HISTORIC AND DESIGN REVIEW COMMISSION

HDRC CASE NO: 2020-461
ADDRESS: 319 DELAWARE
LEGAL DESCRIPTION: NCB 3005 BLK 3 LOT 5
ZONING: R-6, H
CITY COUNCIL DIST.: 1
DISTRICT: Lavaca Historic District
APPLICANT: Julio Vazquez/Payaya Design & Build
OWNER: ROZMEN REBEL D & DIANA ONEAL
TYPE OF WORK: New construction of accessory structure
APPLICATION RECEIVED: October 09, 2020
60-DAY REVIEW: Not applicable due to City Council Emergency Orders
CASE MANAGER: Rachel Rettaliata

The applicant is requesting a Certificate of Appropriateness for approval to install a rear accessory structure constructed from two shipping containers.

TRIM / FINISH PLAN
ROOF PLAN

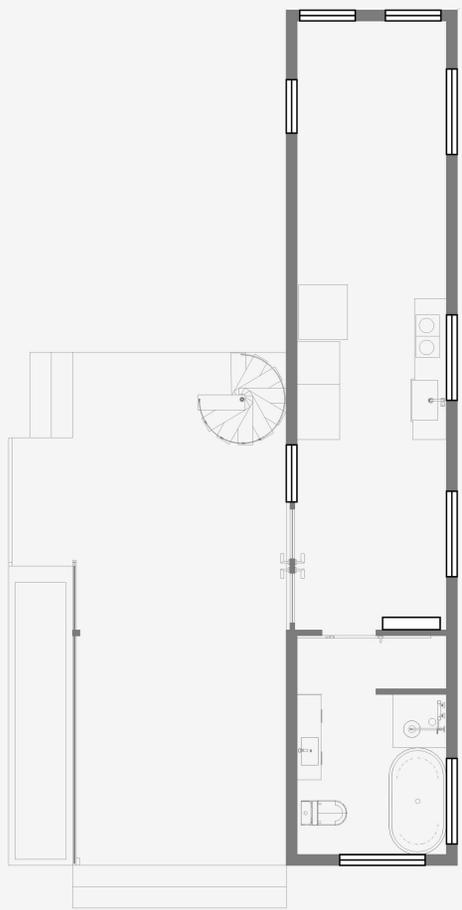
- d. **ROOF FORM** – The applicant has proposed to install shipping containers with a flat roof form that will be used as a terrace. According to Guideline 2.B.i. for New Construction, applicants should incorporate roof forms that are consistent with those predominantly found on the block in pitch, overhang, and orientation. Rear accessory structures in the Lavaca Historic District often feature flat roof forms, although no such forms exist on the block in proximity to the structure. Staff finds the proposal inconsistent with the Guidelines.

- i. That the applicant proposes a rear accessory structure condition that is more consistent with historic development patterns in the district as noted in finding b.
- ii. That the applicant incorporates roof forms that are more consistent with the typologies found in the Lavaca Historic District as noted in finding d.
- iii. That the applicant proposes a fenestration pattern, window opening proportions, and materials that are more consistent with the Guidelines, the Standard Specifications for Windows in Additions, and the historic examples found in the Lavaca Historic District as noted in finding f.
